MONTGOMERY COUNTY
PLANNING COMMISSION

SUBJECT: MCPC #18-0322-009
SOPI – 1 Belmont Avenue

Re: MCPC #18-0322-007
Plan Name: 1 Belmont Avenue
(17,700 sq. ft. commercial on approximately 6.76 acres)
Situate: City Avenue (N); Belmont Avenue (E)
Lower Merion Township

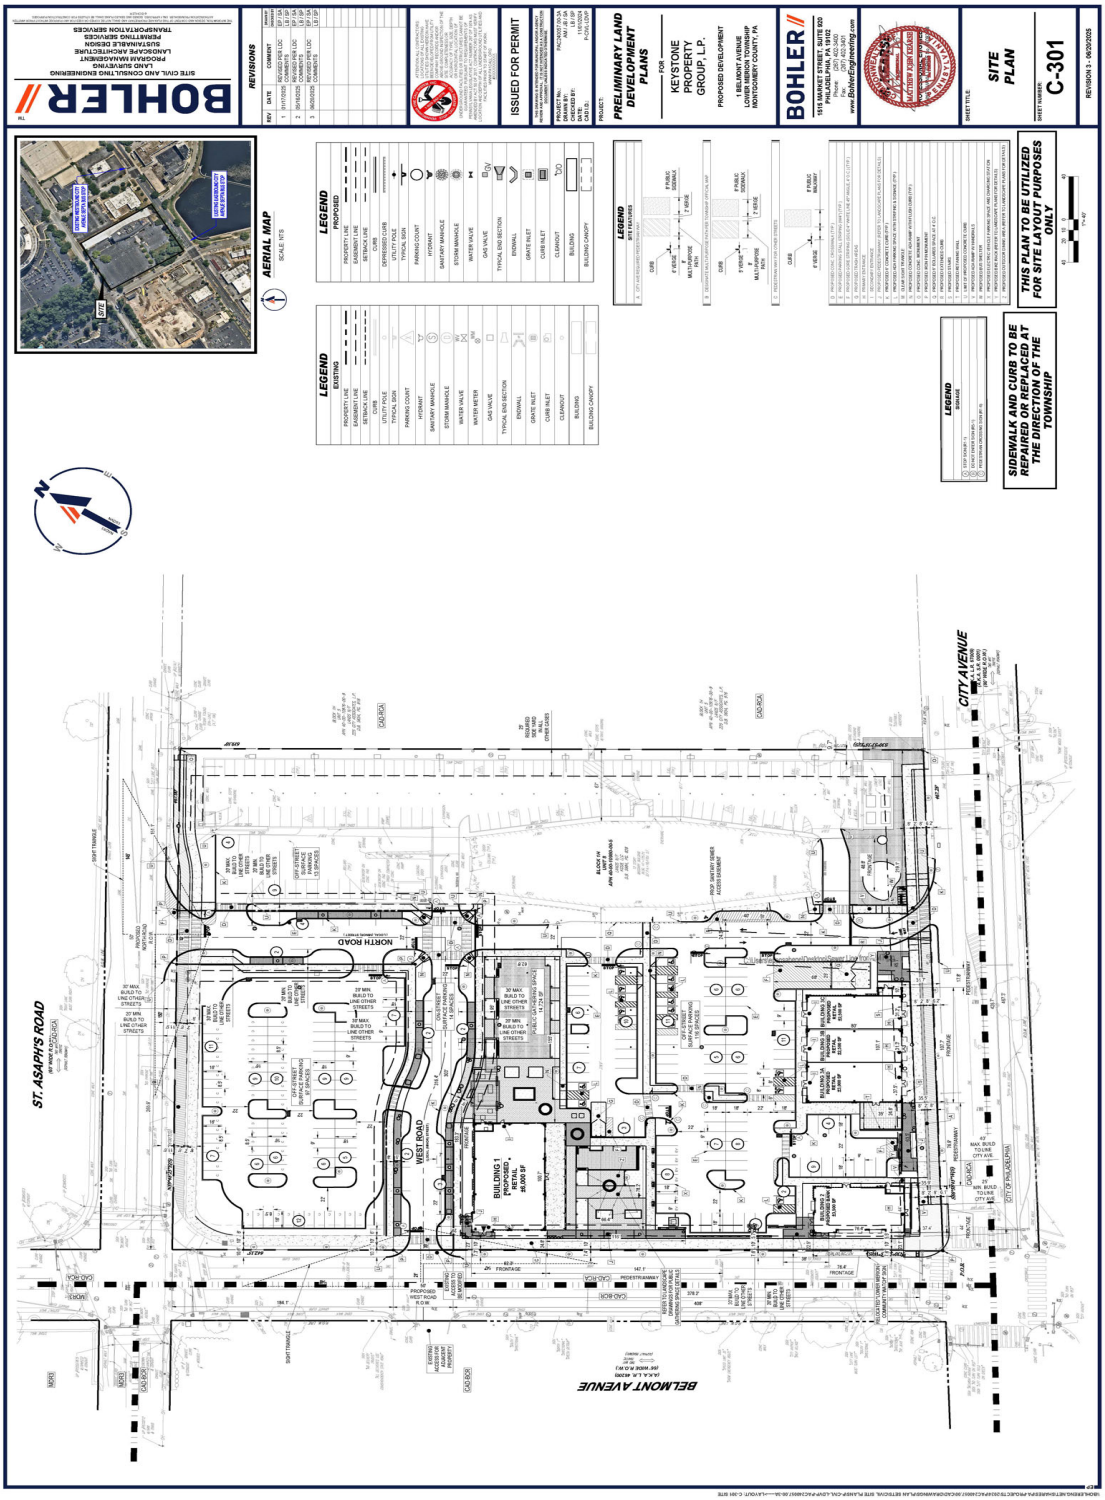
- We suggest that at least one more, warmer-tone color and more natural building material could be added to the design. For example, the graphic below is from a 2022 rendering for a taller building at this same location. The use of warmer tones, such as the lighter-colored brick and wood tone on the upper floors, as well as the gold color metal accents around the windows and on the awning, created a unique architectural appearance that still complemented the gray tones of the existing One Belmont office building.

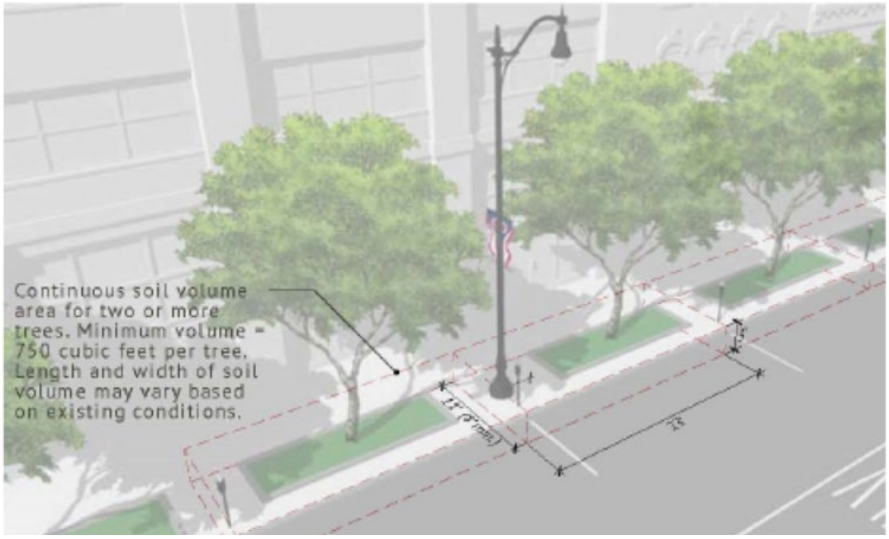
A. Handicapped Parking and Access to Existing Office Building. Several handicapped parking spaces are shown on either side of a pedestrian walkway in the southern parking lot near the entrance to the existing office building. An ADA curb ramp is shown on either side of the pedestrian walkway connecting to a loading zone between ADA parking spaces on the civil plan set; however, no curb ramps in these locations are shown on the landscape plan.
